00 91 03 ADDENDUM NUMBER 03

Owner: City of Wilson, North Carolina
Project: Goldsboro Ph II Water Main Replacement (SRP-D-ARP-0125)
Project No.: WLN22846
Addendum No. 03
Addendum Date: May 2, 2024

END OF SECTION

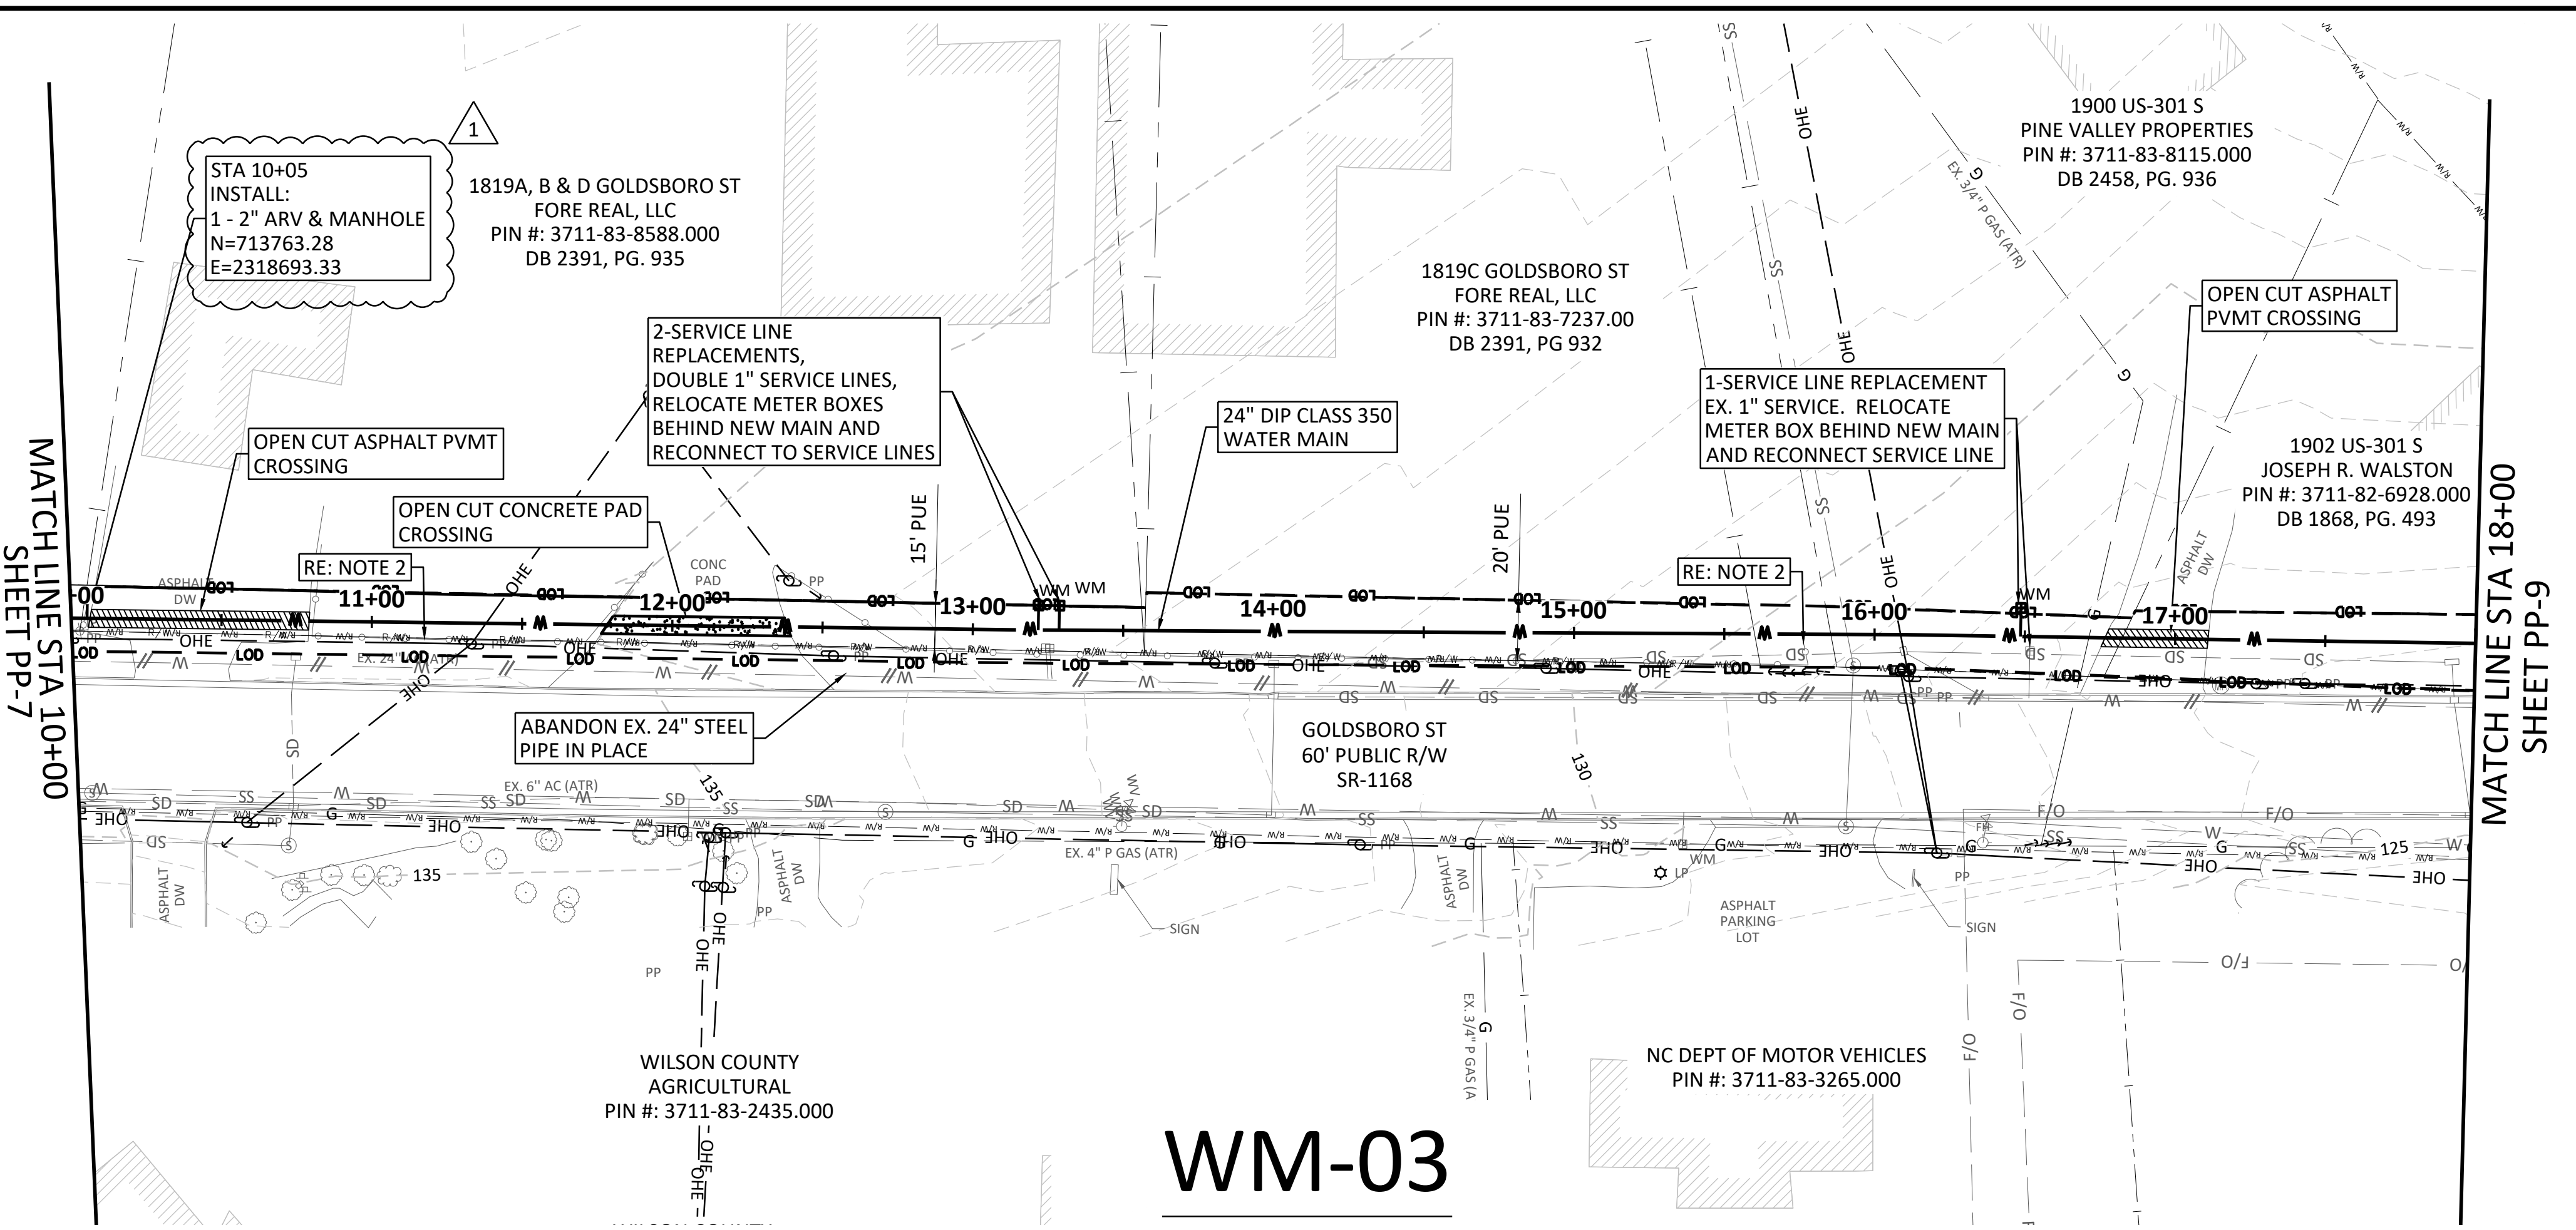
3.01 Sheet PP-8 “Plan and Profile Goldsboro St – Sta 10+00.00 to Sta. 18+00.00”

- A. Amend callout located in Plan View at STA 10+05 as follows:

1. QUESTION: Will you please confirm the sizes of ARV assemblies? Plans show 2ea 12x2, 1ea 16x2 and 1ea 24" but plan view calls out 4" and profile view calls out 2" (sheet PP-8). There seem to be no 3" ARVs on the plans, but 2ea are called out on the bid form.

INSTALL
1 – 2” ARV & MANHOLE
N=713763.28
E2318693.33

RESPONSE: City of Wilson would like to use 2" ARVs on all mains. The plans (PP-8) and bid form have been updated accordingly.
2. QUESTION: Are domestic requirements required based on ARPA funding?

CITY OF WILSON
GOLDSBORO PHASE II WATER MAIN REPLACEMENT
24" WATER MAIN
PLAN AND PROFILE
GOLDSBORO ST - STA 18+00.00 TO STA 21+30

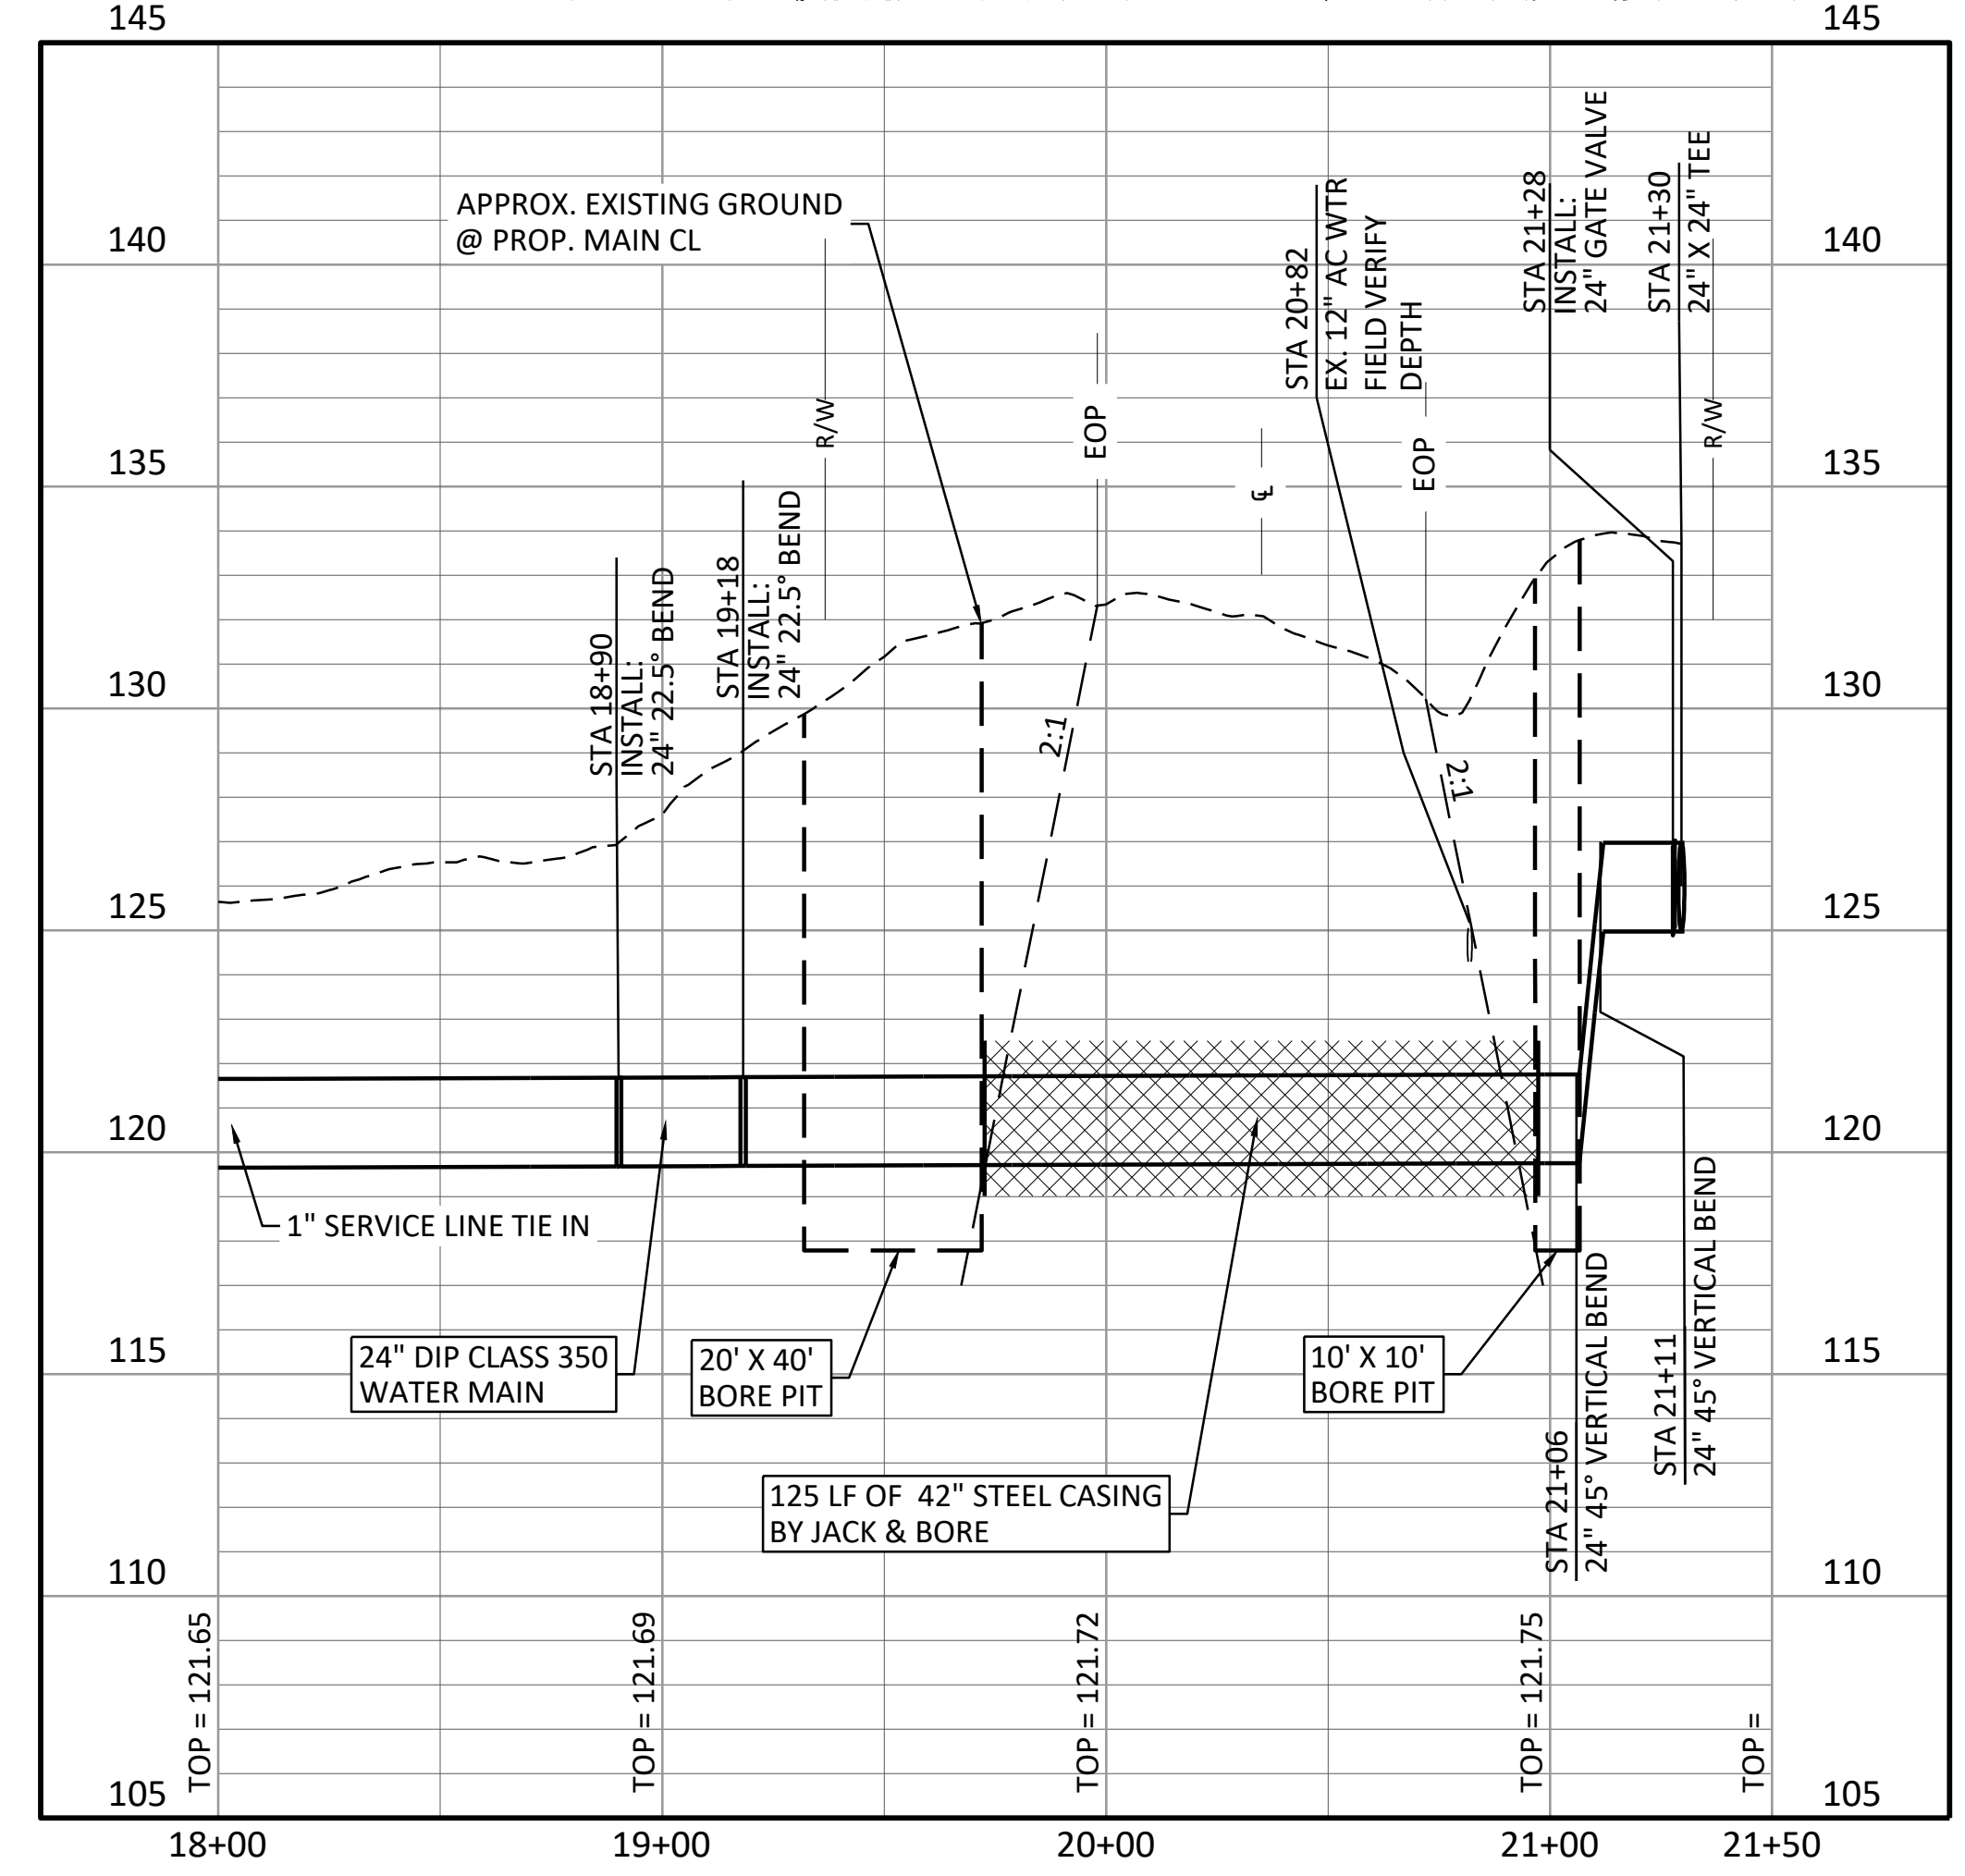
3.02 Sheet PP-9 “Plan and Profile Goldsboro St – Sta 19+00.00 to Sta. 21+30”

- A. Revise easement from 20’ PUE to Variable Width PUE with no TCE.
